Subject : EPC package of Singrauli Stage-III

Drg. Title : TG EQUIPMENT LAYOUT DRAWING AT 0 M

Drg. Title : TG HALL CROSS SECTION

Drg. Title : MACHANICAL GA OF CW AND ACW PUMP HOUSE

UPPER FLOORS IN B-C BAY

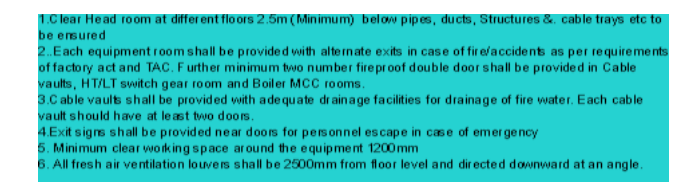
proper routing shall be done to maintain air chnages required for sufficient cooling

proper routing shall be done to maintain required air changes as per design calculation for sufficient cooling

As per specs V/B, B-10, clause 2.01.05,
800 mm wide and 2.1 m high movement passage all around the cable trays
in the cable vault/ cable spreader room for easy laying/maintenance of cables

Unit Nomenclature to be corrected to Unit-8 & 9 wherever it is written as Unit 1 & 2.

mention NTPC drg no also

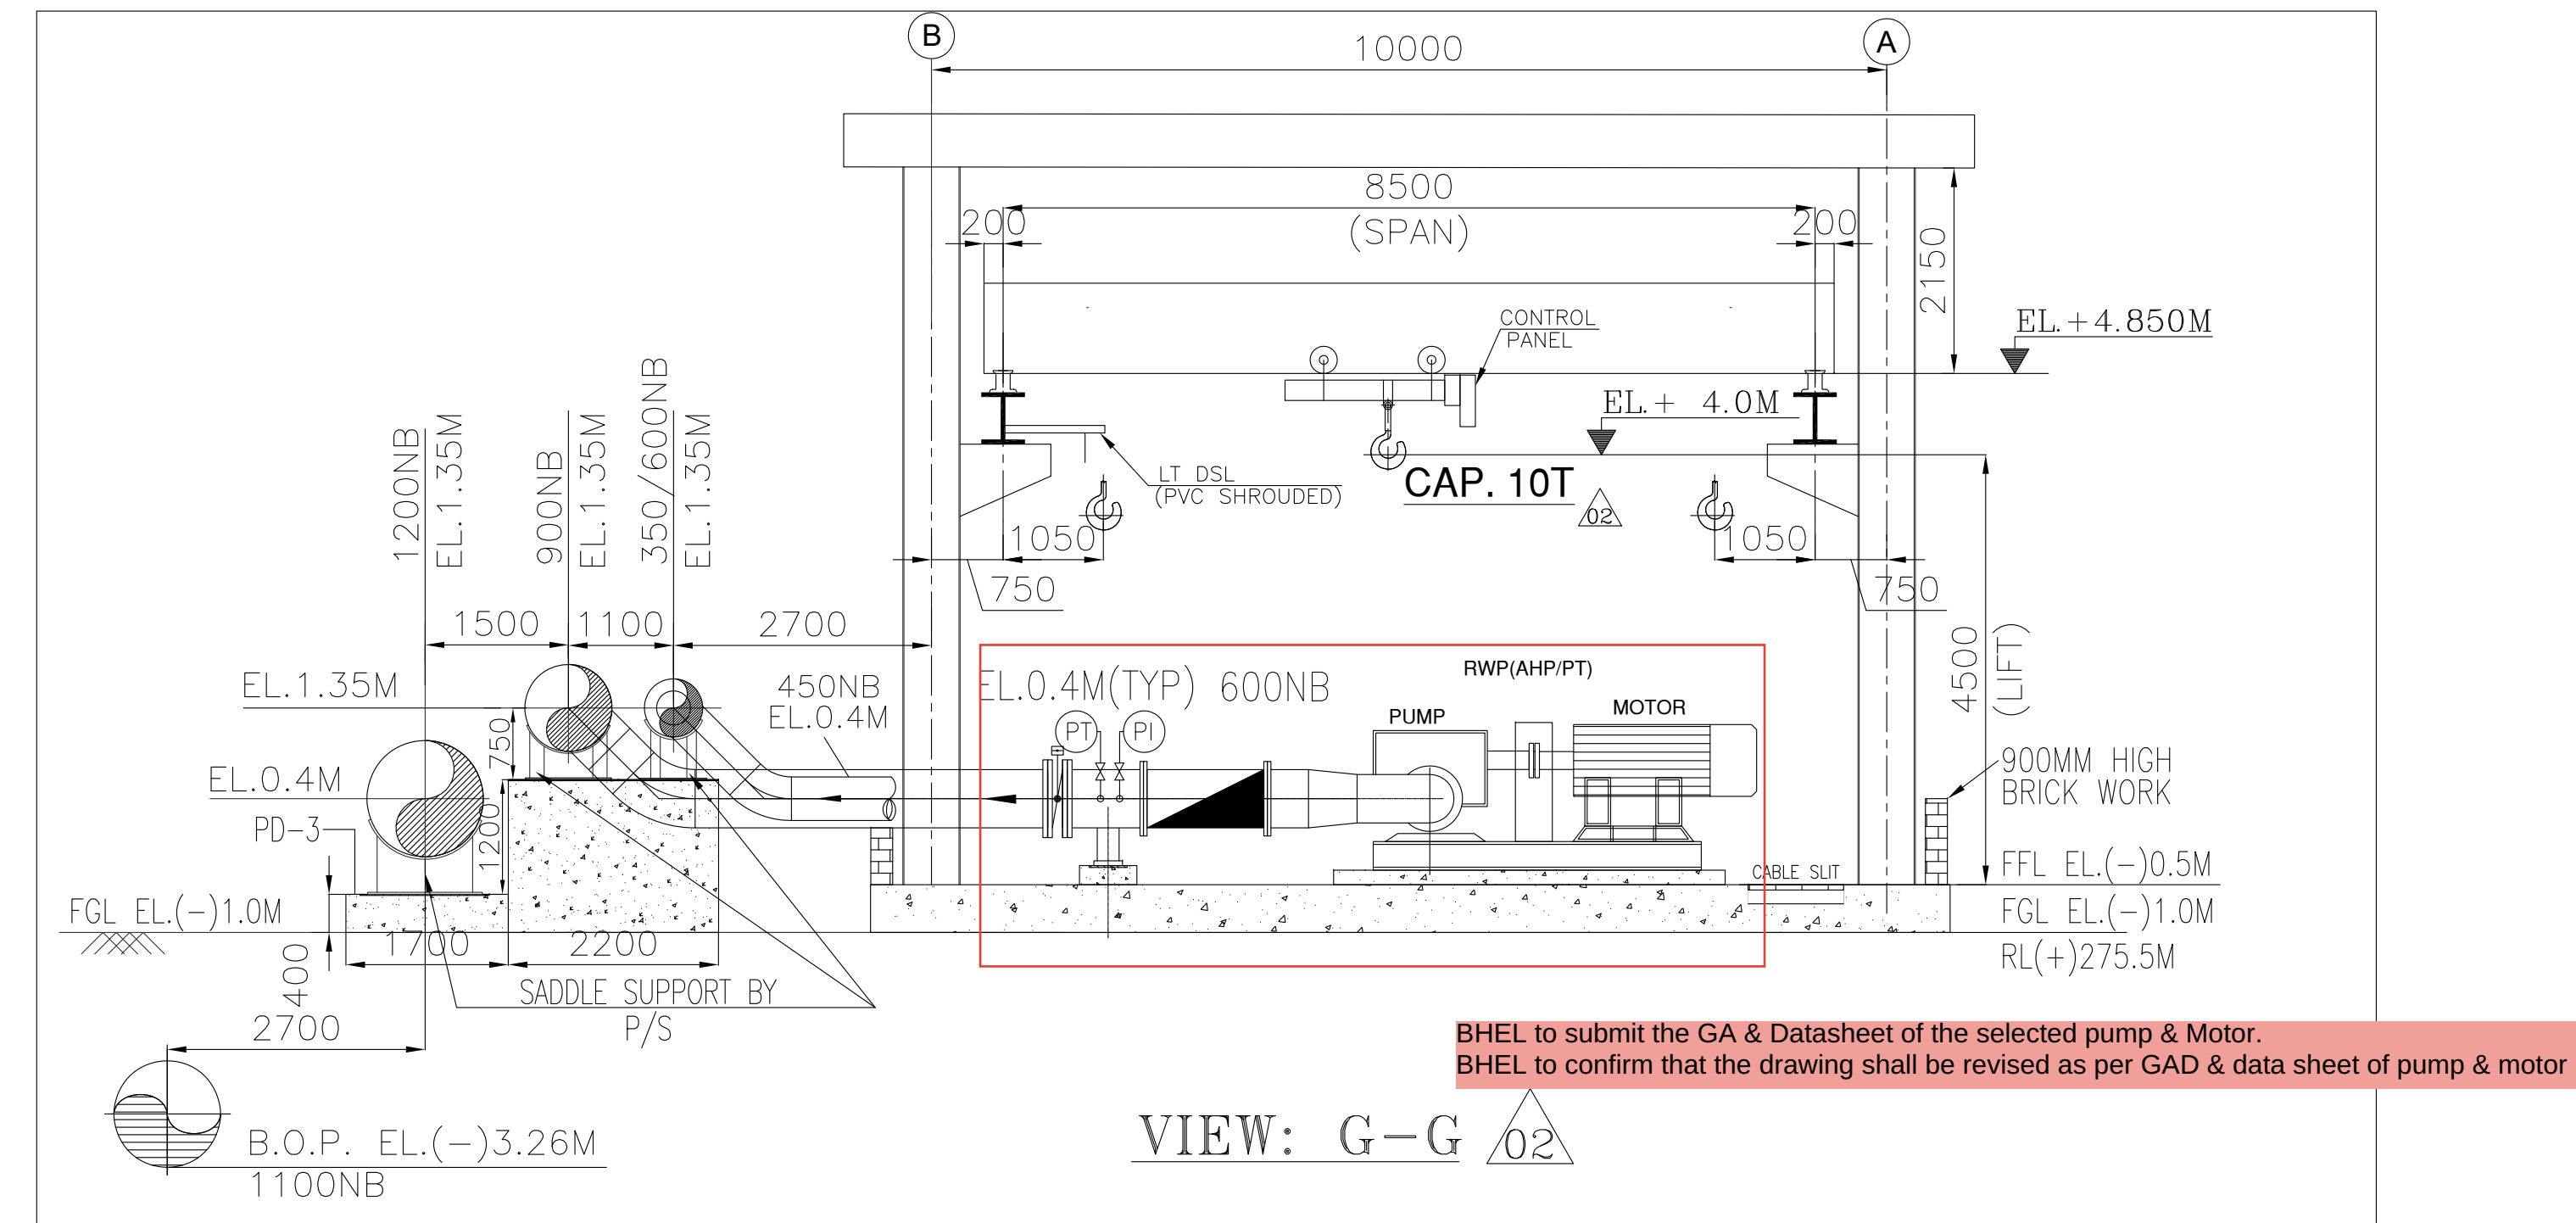
BHEL to confirm that the MECHANICAL GA OF AUX CT P/H shall be as per Drg no.-1150-001-136-PVM-B-071

6	as commented earlier in Rev-), BHEL to indicate the pump house drawing in a separate sheet clearly indicating the pump house iayout and suction & delivery pipe routing.	Updated in the revised drawing.
7	Level of pipe shall be governed by top of curb wall of forebay.	HOLD Removed.
8	Identify these pipes	These pipes are not applicable, Hence has been deleted.
9	Identify these pipes	These pipes are not applicable, Hence has been deleted.
10	level of trestle Shall be finalized after joint site visit	Noted, However, 3.0M height has been decided based on BHEL previous site visit.
11	This stretch of pipe is passing through existing facilities of Stage-I & II. BHEL to conduct joint site visit & site survey with NTPC team to identify the existing structures/facilities and hindrance in routing the pipe in this area.	Noted, Site visit done and drawing revised based on MOM of TCM#110 dtd: 09/10/25.
12	Refer drg. no. 1150-001-136-PVM-B-071, Rev-02 for road and drain layout in this area. Further, extent & level of underground pipe & encasing to be finalized after conducting site visit.	Noted, Site visit done and drawing revised based on MOM of TCM#110 dtd: 09/10/25.

13	Concrete encasing may be suitably strengthened or reinforced at road crossings to ensure no damage to pipe in case of heavy vehicle movement on the road.	Noted and same shall be taken care in respective civil drawing.
14	Indicate locating coordinates of all the pipes at all bends.	Updated in the revised drawing.
15	Why layout of this area is indicated twice in the drawing?	This is the blown-up view, as was desired by NTPC.
16	Also add following in continuation of note 11: Protection of external surface of buried pipes using coating/wrapping/anti-corrosive tape shall be done in line with clause 2.09.03, Sub-Section-A-09, Part-B, Section-VI of technical specifications.	Customer specification shall be followed.
17	BHEL to enclose the list of reference drawing for clarity	Reference drawing list already added in sheet 02.
18	Indicate locating coordinates of all the pipes at all bends.	Updated in the revised drawing.

19	Revise the piping layout to route all the pipes either on pedestal or trestle. Pipes to be buried underground in exceptional cases only.	Noted, Pipes burried are only in exceptional cases.
20	This stretch of ash slurry corridor is not yet final. Re-route the raw water pipes independent of this corridor and keep the crossing with ash slurry corridor under HOLD.	This area of pipe is routed independently, not routed on Ash slurry corridor.
21	Drawing shall be approved in Cat-I after removal of all holds.	However, CAT-II approval is required to proceed with concurrent engineering at our end.

Pipe routing to be revised as commented in previous revision.
